Merged Document Report

Application No.: PL8621

Document Filename
Final Plat_Breezeway Town Homes PUD (5).pdf

FINAL PLAT OF BREEZEWAY TOWN HOMES P.U.D.

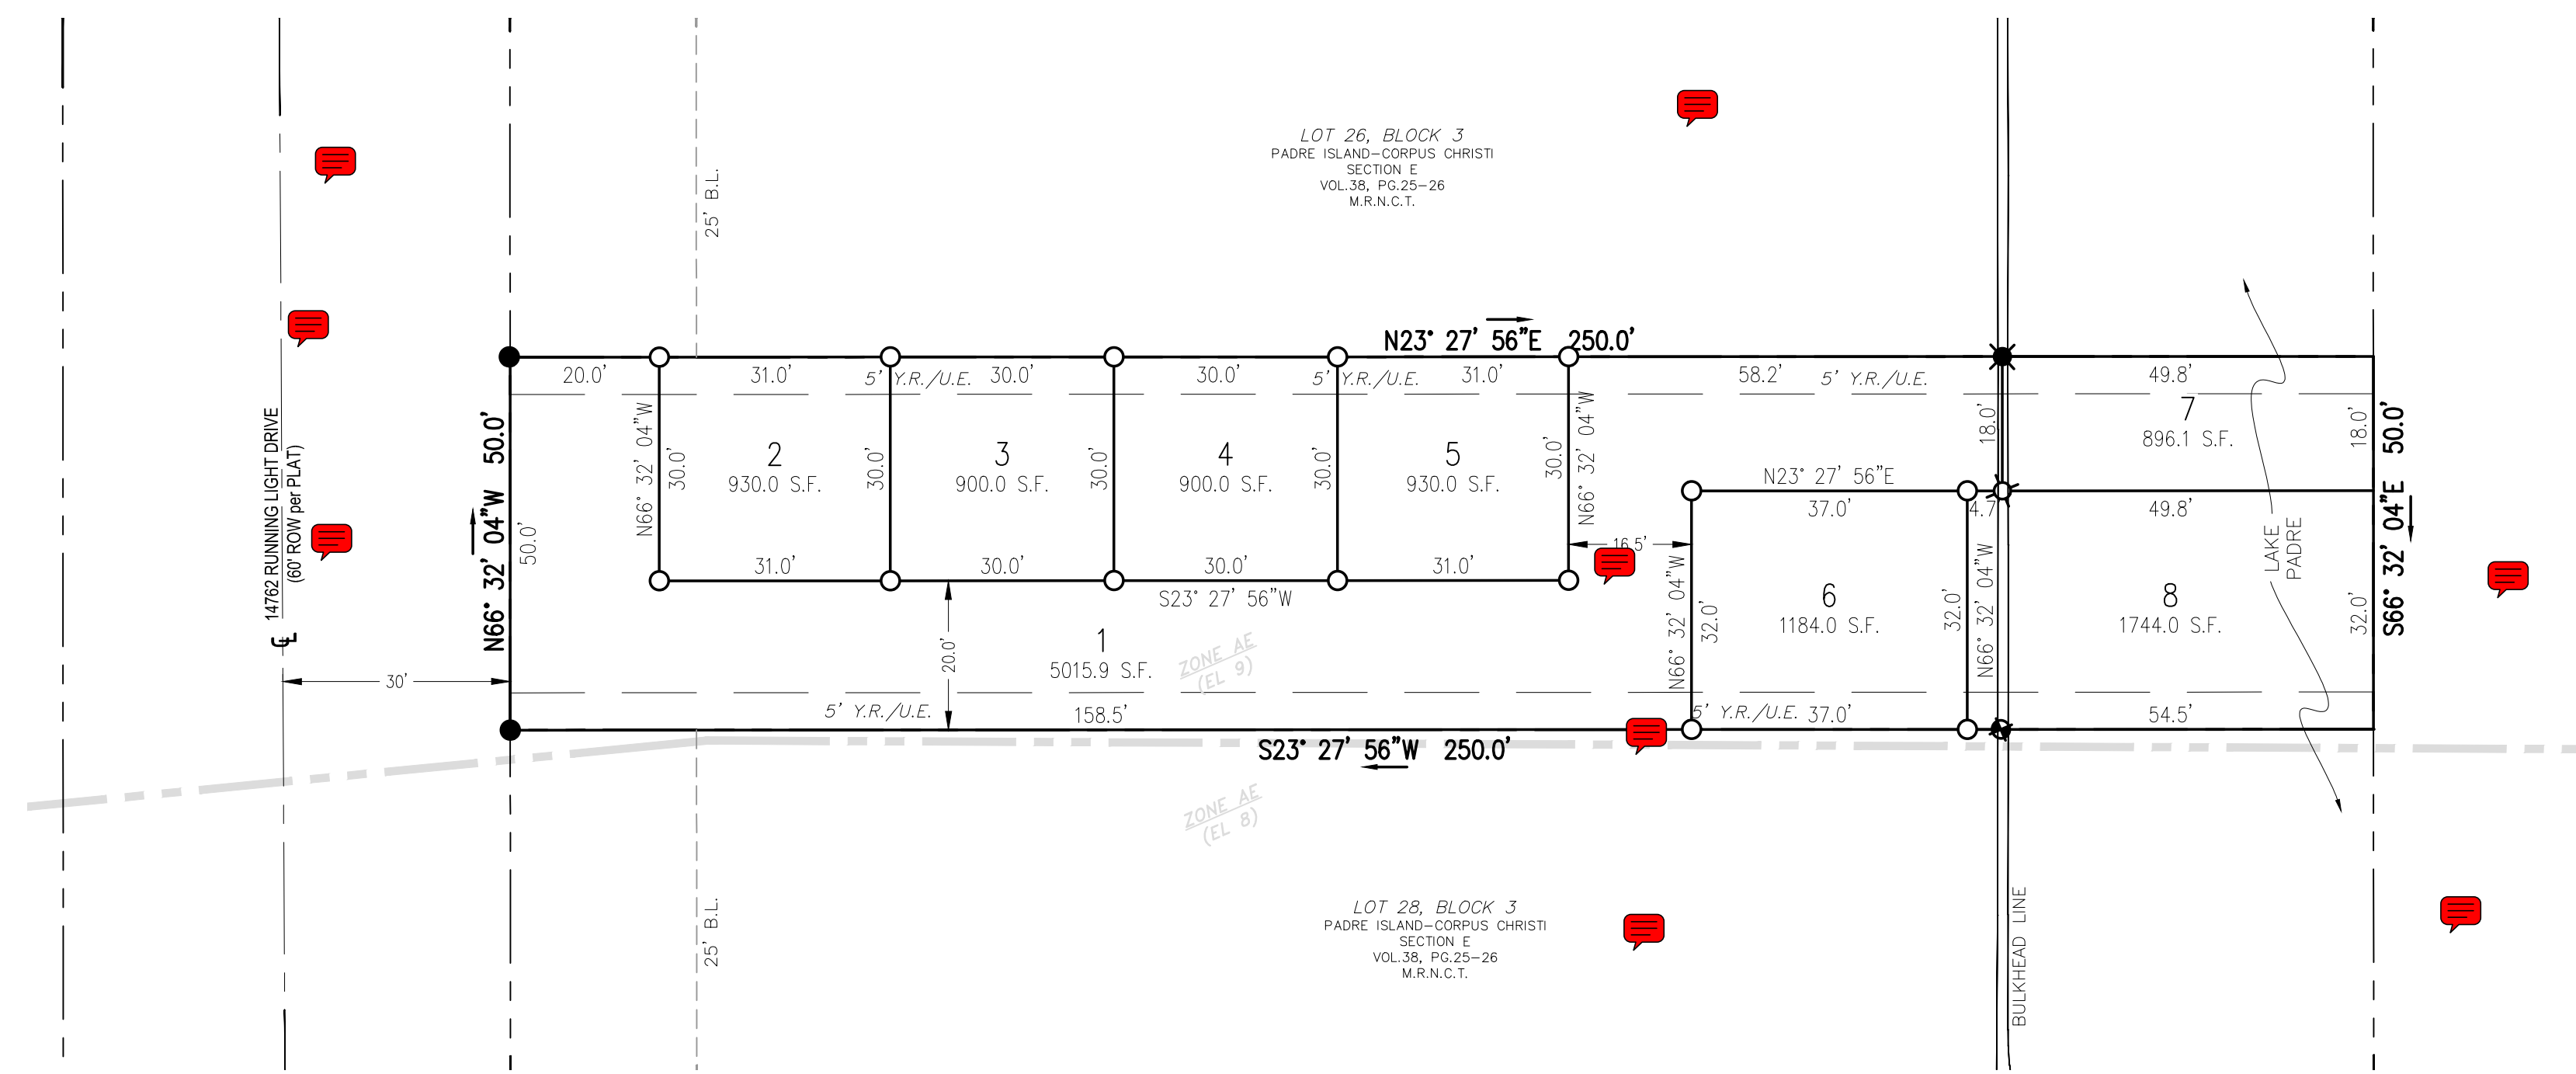
Comment ID	Page Reference	Annotation Type	Author : Department	Status	Review Comments	Applicant Response Comments
7	P001	Note	Andrea Fernandez : DS	Closed	GIS: PL8621 Breezeway Townhomes PUD closes within acceptable engineering standards.	
8	P001	Note	Andrea Fernandez : DS	Closed	CCRTA: This plat is not located along any existing or foreseeably planned CCRTA service route.	
9	P001	Note	Andrea Fernandez : DS	Closed	AEP Transmission: no comment for the subject plat.	
10	P001	Note	Andrea Fernandez : DS	Closed	AEP Tx distribution: no comment	
11	P001	Note	Andrea Fernandez : DS	Closed	Fire comments 1-9: 1 Plat Note: All code reference is based on currently adopted International Fire Code (IFC) 2021 and Corpus Christi Water Distribution Standards. 2 Plat Townhouse construction will be reviewed as commercial property. 3 Plat "Commercial Development shall have a fire flow of 1,500 GPM with 20 psi residual Fire hydrant every 300 feet and operational." 4 Plat 507.5.1 (amendment) Where Required: All premises, other than one-family detached dwellings, where buildings or portions of buildings are located more than 150 feet from a fire hydrant shall be provided with approved on-site hydrants and water mains capable of supplying the fire flow require by the fire official. The minimum arrangement being so as to have a hydrant available for distribution of hose to any portion of building on the premises at distances not exceeding 300 feet. It is noted that a fire hydrant is proposed behind Bldg. 5 5 Plat 912.2.3 (amendment) Proximity to Hydrant: Fire department connections (FDC) for each sprinkler system or standpipe system shall be located not more than 100 feet from the nearest fire hydrant connected to an approved water supply (if required).

Comment ID	Page Reference	Annotation Type	Author : Department	Status	Review Comments	Applicant Response Comments
					<p>6 Plat 503.1.1 (amendment) Buildings and facilities: Approved fire apparatus access roads shall be provided for every facility, building, or portion of a building hereafter constructed or moved into or within the jurisdiction. The fire apparatus access road shall allow access to three (3) sides of buildings in excess of fifteen thousand (15,000) square feet and all sides for buildings in excess of thirty thousand (30,000) square feet.</p> <p>7 Plat 3310.1 Required access. Approved vehicle access for firefighting shall be provided to all construction or demolition sites. Vehicle access shall be provided to within 100 feet of temporary or permanent fire department connections. Vehicle access shall be provided by either temporary or permanent roads, capable of supporting vehicle loading under all weather conditions. Vehicle access shall be maintained until permanent fire apparatus access roads are available.</p> <p>8 Plat D102.1 Access and loading. Facilities, buildings, or portions of buildings hereafter constructed shall be accessible to fire department apparatus by way of an approved fire apparatus access road with an asphalt, concrete or other approved driving surface capable of supporting the imposed load of fire apparatus weighing at least 75,000 pounds.</p> <p>9 Infor. 503.1.1 (amendment) Buildings and facilities: During construction, when combustibles are brought on to the site in such quantities as deemed hazardous by the fire official, access roads and a suitable temporary supply of water acceptable the fire department shall be provided and maintained.</p>

12	P001	Note	Andrea Fernandez : DS	Closed	<p>Fire comments 10-19:</p> <p>10 Infor. Note: An accessible road and a suitable water supply is required once construction materials are brought on site.</p> <p>11 Plat 503.2.1 Dimensions. Fire apparatus access roads shall have an unobstructed width of not less than 20 feet, exclusive of shoulders and an unobstructed vertical clearance of not less than 13 feet 6 inches. It is noted that the fire apparatus fire lanes are 19 ft wide and do not meet the standard.</p> <p>12 Plat D103.1 Access road width with a hydrant. Where a fire hydrant is located on a fire apparatus access road, the minimum road width shall be 26 feet, exclusive of shoulders.</p> <p>13 Plat "The minimum required width of 20 feet that shall be maintained means a clear unobstructed path that allows the passage of fire</p>

Comment ID	Page Reference	Annotation Type	Author : Department	Status	Review Comments	Applicant Response Comments
					<p>apparatus.</p> <p>1. Where Fire Apparatus Access is constructed to the minimum of 20 feet, no parking is allowed within the fire apparatus lane.</p> <p>2. Where a fire hydrant is located on the street, the minimum unobstructed clearance shall be 26 feet. In this instance, no parking is allowed on one side of the street.</p> <p>3. The minimum UDC residential street width is 28 ft. curb to curb. Any parking along the street that reduces the width to less than 20 ft. is prohibited and the Fire Code Official and will require painting "NO PARKING-FIRE LANE" along one side of the street."</p> <p>14 Plat 503.4 Obstruction of fire apparatus access roads. Fire apparatus access roads shall not be obstructed in any manner, including the parking of vehicles. The minimum widths and clearances established in sections D103 shall always be maintained.</p> <p>15 Infor. 503.3 Marking: Where required by the fire code official, approved signs, or other approved notices the include the words NO PARKING-FIRE LANE shall be provided for fire apparatus access roads to identify such roads to prohibit the obstruction thereof. The designation of a fire lane can be marked with conspicuous signs which have the words: " Fire Lane-No Parking" at 50-foot intervals. In lieu of signs, fire lanes may be marked along curbing with the wording, "Fire Lane-No Parking" at 15-foot intervals.</p> <p>16 Infor. "</p> <p>D103.5 Fire apparatus access road gates.(If applicable) Gates securing the fire apparatus access roads shall comply with all the following criteria: Single gate width shall not be less than 20 feet. 12 foot gate width is required for a divided roadway. Electric gates shall be equipped with a means of opening the gate by fire department personnel for emergency access. Emergency opening devices shall be approved by the fire code official. Note: The use of a Knox Gate Switch is currently required by the Fire Official. Methods of locking shall be submitted for approval by the fire code official. Note: The Knox Padlock is currently required by the Fire Official. Electric gate operators, where provided, shall be listed in accordance with UL 325. Gates intended for automatic operation shall be designed, constructed, and installed to comply with the requirements of ASTM F 2200 (if applicable)"</p> <p>17 Infor. R313.1 Townhouse automatic fire sprinkler systems. An automatic residential fire</p>

Comment ID	Page Reference	Annotation Type	Author : Department	Status	Review Comments	Applicant Response Comments
					<p>sprinkler system shall be installed in townhouses only when three (3) or more attached dwelling units are constructed, and transient uses (occupancies less than thirty (30) days are allowed).</p> <p>18 Infor. R313.1. Design and installation. Automatic residential fire sprinkler system for townhouses shall be designed and installed in accordance with Sections P2904 or NFPA 13D.</p> <p>19 Plat Commercial development of the property will require further Development Services review.</p>	
19	P001	Note	Andrea Fernandez : DS	Closed	<p>Parks:</p> <p>-Park and Recreations is not responsible for the landscaping or drainage on site for project scope or any other feature of project.</p> <p>-Number of Residential Single Family Homes mentioned in Plat total the amount of (5). If any number of dwelling units changes then fees will be adjusted at time of change and recalculated to provide accurate number for fees.</p> <p>Dwelling Units: 5 Fee: \$462.50 Total Due: \$2,312.50</p>

20	P001	Note	Andrea Fernandez : DS	Closed	<p>Traffic comments 1-6</p> <p>1 Informational: Proposed driveway access to a public City Street shall conform to access management standards outlined in Article 7 of the UDC (UDC 7.1.7)</p> <p>2 Informational: "Sidewalks required on both sides of local street as per IDM Chapter 6 - Street Design Requirements. Table 6.2.2 Street Right-of-Way Dimension Standards"</p> <p>3 Informational: The PW-Traffic Department (Right-of-Way Division) is responsible for reviewing and permitting new construction and repairs/modifications to driveways, sidewalks, and curb and gutter. The review and approval of the permit must be approved prior to the issuance of the building permit (issued by DSD). (Refer to Municode Chapter 49-30 for permit requirements.)</p> <p>4 Informational: Public improvement plans shall include all signage and pavement markings needed for traffic operations (e.g. signage, striping, traffic mitigation devices) in addition to standard "regulatory" STOP and street name blade sign installations. Additionally, cul-de-sacs must include either "NO OUTLET" or "DEAD END" signage. Temporary Dead-Ends should include the appropriate object markers and one-way streets must include signage for any one-way designations</p>

Comment ID	Page Reference	Annotation Type	Author : Department	Status	Review Comments	Applicant Response Comments
					<p>and affected side streets. Reference: Texas MUTCD based on CC UDC Article 8.1.3.A</p> <p>5□Informational:□All traffic signs shall be furnished and installed by the Developer in accordance to specifications of, and subject to, latest version of the "Texas Manual on Uniform Traffic Control Devices (TMUTCD), public improvement plan reviews and inspections, by the City. This includes furnishing and installing "STOP" signs. Reference: Texas MUTCD based on CC UDC Article 8.1.3.A. All entries to private streets from public streets shall be clearly signed by the owners or home owners association as a "private street." (Reference UDC Article 8.2.1.J. Private Streets)</p> <p>6□Informational:□The developer or their representative is required to submit a "Street Lighting Plan", indicating the proposed locations and fixture type of street lights, for review and approval to the City's Traffic Engineering Department. All new fixture types will be LED. Street lights shall meet design requirements per the City of Corpus Christi Infrastructure Design Manual (IDM) Chapter 8 - Street Lighting Design Policy and Guidelines.</p>

21	P001	Note	Andrea Fernandez : DS	Closed	<p>Traffic omments 7-11:</p> <p>7□Informational:□The "Street Lighting Plan" shall indicate all existing street lights within 500-ft (+/-) of proposed street lights along tangent street sections. Preliminary "written" approval of the "Street Lighting Plan", by the City's Traffic Engineering Department, is required before the utility company (AEP or NEC) can start the design of the street lighting system and determine developer fees, which are required for plat recordation. Traffic Engineering issues a Letter of Authorization to the utility company, allowing for construction of the street lighting system, once this process is complete.</p> <p>8□Informational:□A ROW Construction Permit, issued by PW-Traffic Department (Right-of-Way Division), is required for any work obstructing, closing, or occupying public right-of-way (Reference Chapter 49-2). Work within the Right-of-Way without a permit is subject to daily Non-Compliance Fees (Reference Municode Chapter 49).</p> <p>9□Informational:□Any street excavation, utility cut, or utility tap requires a permit issued by the Traffic Department (Right-of-Way Division). Restoration requirements are subject to the street Pavement Condition Index (PCI) and street age. New streets (Any street 0-6 years and / or PCI ≥ 80) will require</p>

Comment ID	Page Reference	Annotation Type	Author : Department	Status	Review Comments	Applicant Response Comments
					<p>restoration of 25-ft beyond the outermost edge of the excavation and up to curb to curb repair. Older streets (Any street > 6 years or PCI < 80) will require restoration of 10-ft beyond the outermost edge of the excavation and up to full lane (Refer to Municode Section 49-47-1).</p> <p>10 Informational: Culd-de-Sacs shall conform to access management standards outlined in Article 8 of the UDC (UDC 8.2.1 G)</p> <p>11 - The developer can reach out to ROWManagement@cctexas.com for further assistance regarding the ROW Construction Permit they will be required to submit prior to any temporary and / or permanent driveway off Yorktown Blvd.</p> <p>The ROW Construction permit must be submitted and approved prior to any form of construction within City ROW.</p> <p>Any contractor working within City ROW without an approved ROW Construction Permit can be held in non-compliance and can be subject to a fee of \$1,500 per day of unpermitted work, as per City of Corpus Christi Municipal Code 49-112 (9).</p> <p>If you have any further questions, please feel free to contact ROW / Traffic at your convenience.</p>

22	P001	Note	Mark Zans : LD	Closed	<p>Fire comments: updated 5/2/25</p> <p>503.2.1 Dimensions. Fire apparatus access roads shall have an unobstructed width of not less than 20 feet, exclusive of shoulders and an unobstructed vertical clearance of not less than 13 feet 6 inches. It is noted that the fire apparatus fire lanes are 16.5' and 18' and do not meet the standard.</p>	
24	P001	Note	Mark Zans : LD	Closed	<p>Fire comment#2 - updated 5/2/25</p> <p>"The minimum required width of 20 feet that shall be maintained means a clear unobstructed path that allows the passage of fire apparatus.</p> <p>1. Where Fire Apparatus Access is constructed to the minimum of 20 feet, no parking is allowed within the fire apparatus lane.</p> <p>2. Where a fire hydrant is located on the street, the minimum unobstructed clearance shall be 26 feet. In this instance, no parking is allowed on one side of the street.</p> <p>3. The minimum UDC residential street width is 28 ft. curb to curb. Any parking along the street that reduces the width to less than 20 ft. is prohibited and the Fire Code Official and will require painting "NO PARKING-FIRE LANE" along one side of the street."</p>

25	P001	Note	Mark Zans : LD	Closed	<p>Fire comment #3: updated 5/2/25</p>

Comment ID	Page Reference	Annotation Type	Author : Department	Status	Review Comments	Applicant Response Comments
					it is noted that the plat has slightly changed the fire access road width to 20 ft. Be advised that this is the absolute minimum width of a fire apparatus road and therefore no parking will be allowed on this access lane and shall be appropriately posted as a No Parking area. Note comment #16 Note also that the fire department would need access to the dock in the event of a dock or boat fire. The Fire Marshal will consider allowing this development provided that a 4 inch standpipe and hose connections be installed at this site. You may contact the Fire Mashal's Office for further direction.	
26	P001	Note	Mark Zans : LD	Closed	Fire comment #3: updated 5/2/25 it is noted that the plat has slightly changed the fire access road width to 20 ft. Be advised that this is the absolute minimum width of a fire apparatus road and therefore no parking will be allowed on this access lane and shall be appropriately posted as a No Parking area. Note comment #16 Note also that the fire department would need access to the dock in the event of a dock or boat fire. The Fire Marshal will consider allowing this development provided that a 4 inch standpipe and hose connections be installed at this site. You may contact the Fire Mashal's Office for further direction.

27	P001	Note	Mark Zans : LD	Closed	Updated comment 4/20/2026 - In note #7 please remove the words 'or the designated common area. As worded now this conflicts with note #9.	
28	P001	Note	Mark Zans : LD	Closed	Updated comments 4/20/2026: Please provide a copy of the HOA documents for review.	
29	P001	Note	Mark Zans : LD	Closed	Updated comment 4/20/26 Please dimension half street distance.	
15	P001	Note	Caleb Wong : STREET	Closed	PW STR: A person shall be held responsible for damage to and in public right-of-way for the criteria outlined in Sec. 49-39-9 in the City's Municipal Code and will be held responsible for restoring the City assets per Municipal Code Sec. 49-47-1, Sec. 49-54-6 and Sec. 49-49-3. For further information, please email ROWManagement@cctexas.com.

Comment ID	Page Reference	Annotation Type	Author : Department	Status	Review Comments	Applicant Response Comments
16	P001	Note	Caleb Wong : STREET	Closed	PW STR: Please refer to City of Corpus Christi Standards and Specifications for proposing roadwork, curb and gutter, sidewalk, utilities, etc and have the standards included in the plan set and the specifications referenced. Wherever available, please include a table of contents for which standards and specifications were used.	
1	P001	Note	Bria Whitmire : WW	Closed	<p>Improvements Required for Recordation, per UDC 8.1.4.</p> <ul style="list-style-type: none"> A. Streets: No Sidewalks: No B. Water: No Fire hydrants: No C. Wastewater: No D. Stormwater: No E. Public open space: No F. Permanent monument markers: No <p>Please note, improvements required should be constructed to city standards, found in Article 8 and the IDM.</p>
